# Access Audit Site Report

**Lake Bob Sandlin State Park**

**Accessibility Evaluation**

**Inspection Date: 04/06/2022**

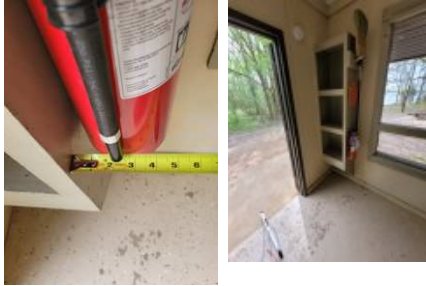
| Finding Number | Area Description  | Lat/Long                   | Finding   | As Built                                       | Recommendation  | Citation  | Photos   | Figure  |
|----------------|---|----------------------------|---|--|---|---|--|---|
| 233            | Moccasin Track/Broken Bow (MT/BB) Camping Areas: MT/BB - Shelter Campsite | [33.0569423 , -95.0802056] | The surface of parking spaces and pull-up spaces shall be firm and stable. The slope of the surface of parking spaces and pull-up spaces shall not be steeper than 1:48 in any direction. EXCEPTION: Where the surface is other than asphalt, concrete, or boards, slopes not steeper than 1:20 shall be permitted when necessary for drainage. | Site 80 - Right space - 4%, large crack within | Correct surface of parking spaces to be firm and stable with slopes max of 2.08% or 5% for surfaces other than concrete, asphalt or boards as a smart practice. | 2015 ABAAS Section: 1012.4, 1012.5, 1012.5 EXCEPTION  |   |   |
| 234            | Moccasin Track/Broken Bow (MT/BB) Camping Areas: MT/BB - Shelter Campsite | [33.0569378 , -95.080207]  | There is no accessible route to the Shelter 80. At least one accessible route shall connect accessible buildings, accessible facilities, accessible elements, and accessible spaces that are on the same site.  | Lacks AR to Shelter 80                         | Create an accessible route with crushed stone or other outdoor material from parking or walkway to Shelter 80.  | 2015 ABAAS Section: F206.2.2<br><br>2012 TAS Section: 206.2.2<br><br>2010 ADAS Section: 206.2.2 |  |  |

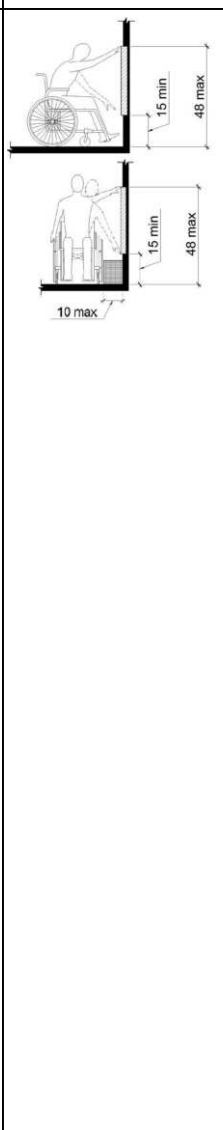
| Finding Number | Area Description  | Lat/Long                   | Finding   | As Built                                   | Recommendation   | Citation   | Photos   | Figure |
|----------------|---|----------------------------|---|--|--|--|--|--------|
| 235            | Moccasin Track/Broken Bow (MT/BB) Camping Areas: MT/BB - Shelter Campsite | [33.0569356 , -95.080211]  | The threshold has a gap greater than 1/2 inch wide. Hand-activated door opening hardware, handles, pulls, latches, locks, and other operating devices on accessible doors shall have a shape that is easy to grasp with one hand and does not require tight grasping, tight pinching or twisting of the wrist to operate. Hardware shall be 34 inches minimum and 48 inches maximum above the finish floor or ground.   | Shelter 80 door - knob, 1.25" gap          | For all doors along the public circulation fill gaps at door entries to max .5". For all doors along the public circulation route, replace hardware with lever hardware or hardware operable without a tight pinch or grasp. | 2010 ADAS Section: 404.2.3, 404.2.7, 404.2.4, 404.2.11, 404.2.11 Exception               |   |        |
| 236            | Moccasin Track/Broken Bow (MT/BB) Camping Areas: MT/BB - Shelter Campsite | [33.0569378 , -95.0802056] | An item or items project more than 4 inches into the circulation path. Wall-mounted objects that have leading edges between 27 inches and 80 inches from the floor must not project more than 4 inches into the circulation path. Protruding objects that extend to the floor or within 27 inches of the floor are cane detectable and are therefore not hazardous. Where it is necessary or desirable to have objects protrude from the wall, a manner of cane detection must be provided. | Site 80 - Fire extinguisher protrudes 4.5" | Relocate protruding objects or place cane detectable warning or bollard at foot of item.   | 2015 ABAAS Section: 307.2<br><br>2012 TAS Section: 307.2<br><br>2010 ADAS Section: 307.2 |  |        |

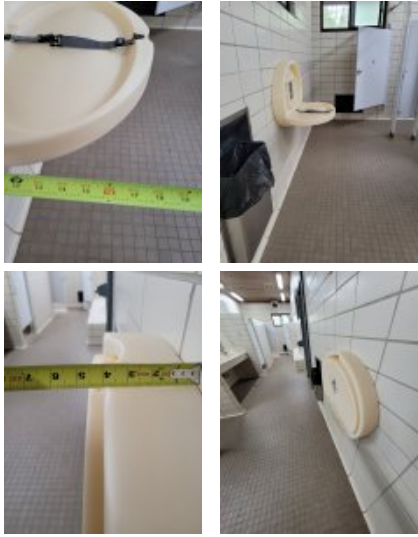
| Finding Number | Area Description  | Lat/Long                    | Finding   | As Built  | Recommendation   | Citation  | Photos   | Figure  |
|----------------|---|-----------------------------|---|---|--|---|--|---|
| 237            | Moccasin Track/Broken Bow (MT/BB) Camping Areas: MT/BB - Shelter Campsite | [33.0569412 , -95.080223 1] | The operable part is positioned too high for either a side or front approach. Where a clear floor or ground space allows a parallel approach to an element and the side reach is unobstructed, the high side reach shall be 48 inches maximum and the low side reach shall be 15 inches minimum above the finish floor or ground. Where a forward reach is unobstructed, the high forward reach shall be 48 inches maximum and the low forward reach shall be 15 inches minimum above the finish floor or ground. | Site 80 - Light switches at 53" AFF, hooks at 72" AFF | Remount operable parts to be in reach range of 15" min to 48" max. | 2015 ABAAS Section: 308.1<br><br>2012 TAS Section: 308.1<br><br>2010 ADAS Section: 308.1  |   |  |
| 238            | Moccasin Track/Broken Bow (MT/BB) Camping Areas: MT/BB - Campsite         | [33.0561071 , -95.081534 7] | Thresholds, if provided at doorways, shall be 1/2 inch (13 mm) high maximum. Raised thresholds and changes in level at doorways shall comply with 302 and 303. Changes in level of 1/4 inch (6.4 mm) high maximum shall be permitted to be vertical. Changes in level between 1/4 inch (6.4 mm) high minimum and 1/2 inch (13 mm) high maximum shall be beveled with a slope not steeper than 1:2. Changes in level greater than 1/2 inch (13 mm) high shall be ramped, and shall comply with 405 or 406.         | Cottage 66 door - 1" CIL at door                      | Repair, bevel or ramp CIL at doorway.                              | 2015 ABAAS Section: 303.3, 404.2.5, 303.2, 303.4<br><br>2012 TAS Section: 303.3, 404.2.5, 303.2, 303.4<br><br>2010 ADAS Section: 303.3, 404.2.5, 303.2, 303.4 |  |  |

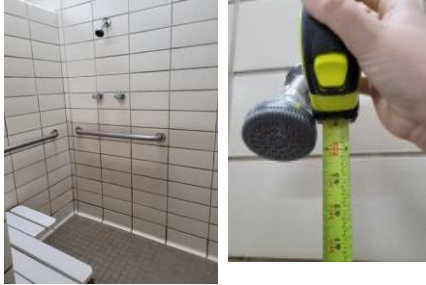
| Finding Number | Area Description  | Lat/Long                  | Finding  | As Built                     | Recommendation  | Citation   | Photos  | Figure  |
|----------------|---|---------------------------|--|------------------------------|---|--|---|---|
| 275            | Moccasin Track/Broken Bow (MT/BB) Camping Areas: MT/BB - Women's Restroom | [33.0567085, -95.0815508] | There are not enough accessible toilet compartments. The room contains toilet compartments. A minimum of 1 must be wheelchair accessible.  | Ambulatory stall only        | Create a wheelchair accessible stall with grab bars and fixtures mounted in correct locations and at correct heights. | 2015 ABAAS Section: F213.3.1<br>2012 TAS Section: 213.3.1<br>2010 ADAS Section: 213.3.1      |   |   |
| 276            | Moccasin Track/Broken Bow (MT/BB) Camping Areas: MT/BB - Women's Restroom | [33.056704, -95.0815508]  | The ambulatory stall is not between 35" to 37" wide and 60" deep.  | ambulatory stall 41.5" width | Correct ambulatory stall to be 35" to 37" wide and minimum 60" deep.  | 2015 ABAAS Section: 604.8.2.1<br>2012 TAS Section: 604.8.2.1<br>2010 ADAS Section: 604.8.2.1 |  |  |
